Request for Bids	Marshall University Office of Purchasing One John Marshall Drive Huntington, WV 25755-4100 Direct all inquiries regarding this order to: (304) 696-2599	Bid # R2001202

Marshall University Baseball Stadium

Addendum Number: No. 2

The purpose of this addendum is to modify the solicitation identified as ("Solicitation") to reflect the change(s) identified and described below.

5 ELECTRIC WATER HEATER DETAIL — P501 — NTS

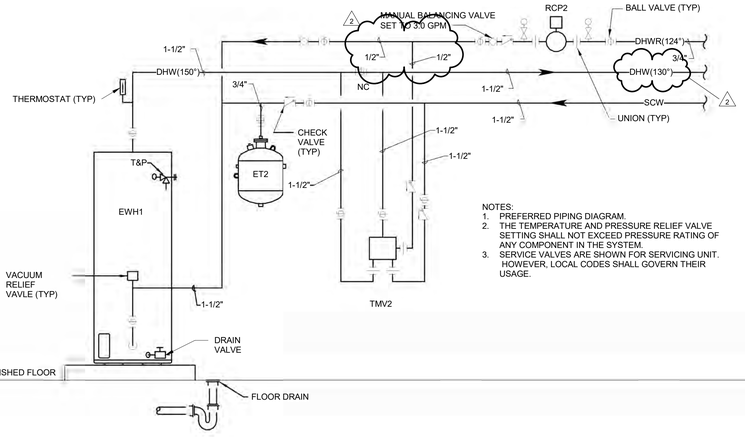
55. Q. Please provide a Schedule for the thermostatic mixing valve Tagged TMV2 shown on Drawing P501 Electric Water Heater Detail 5.

MDP

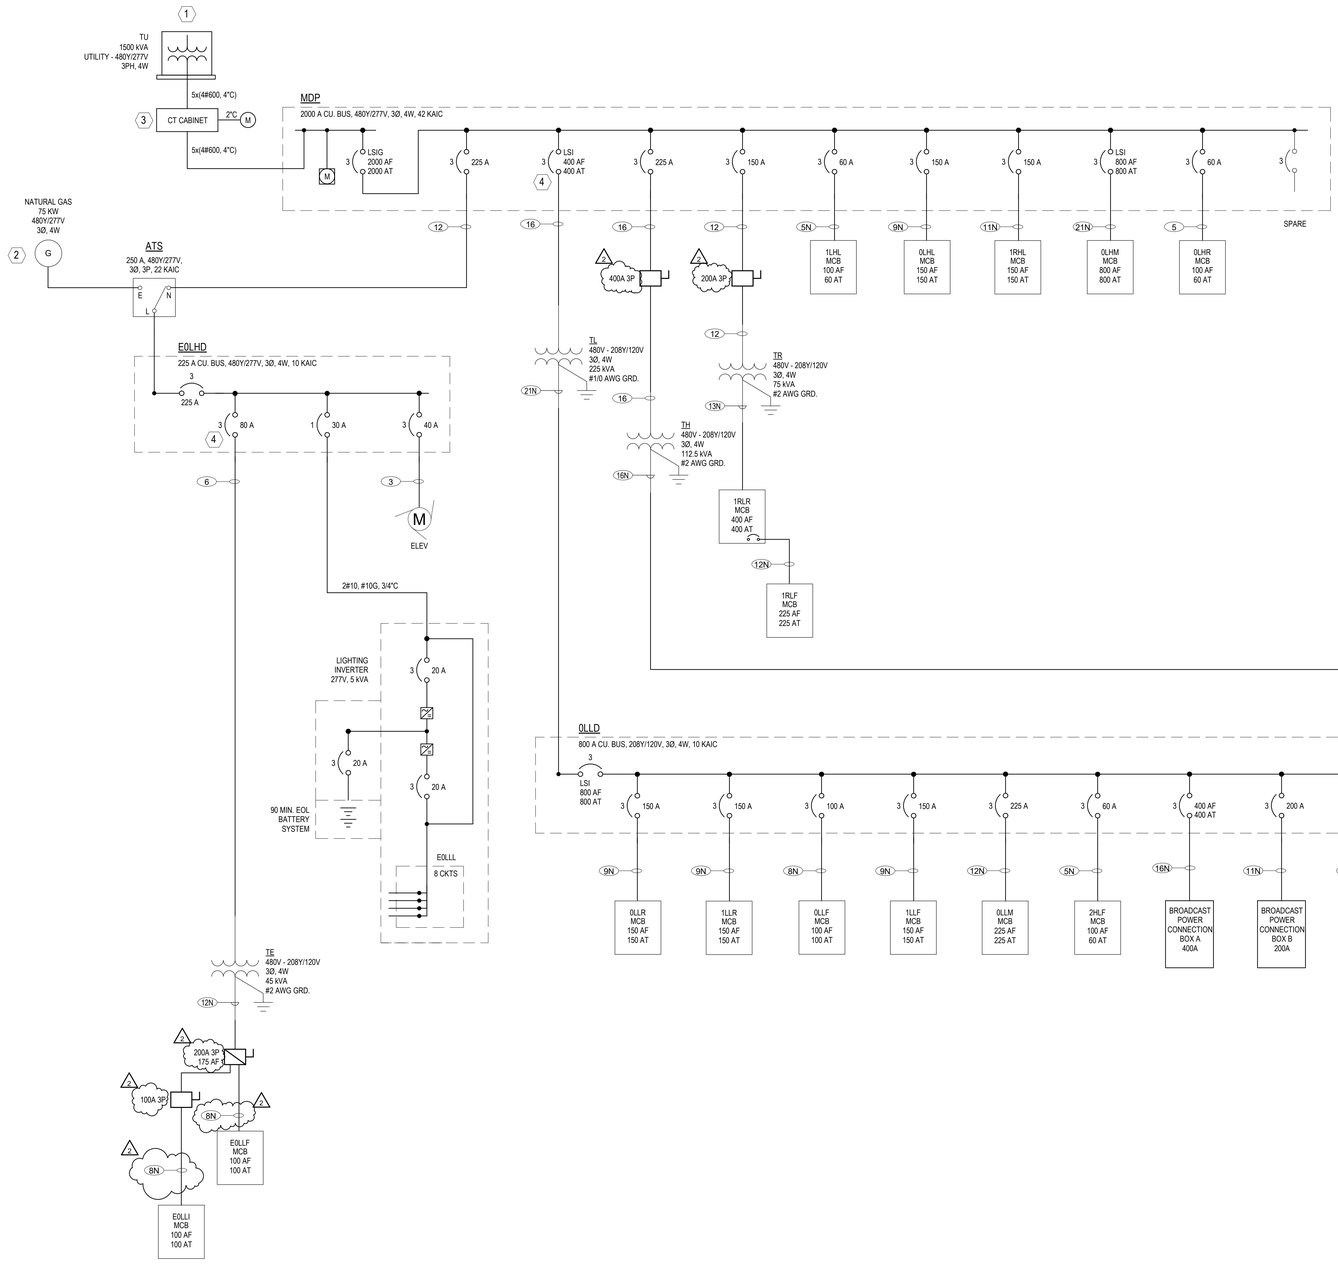
5. Q. Drawing E601 shows Panel 2HLF being fed from Panel OLLD however Drawing E602 shoes Panel 2HLF being fed from Panel OHLD, can you clarify?
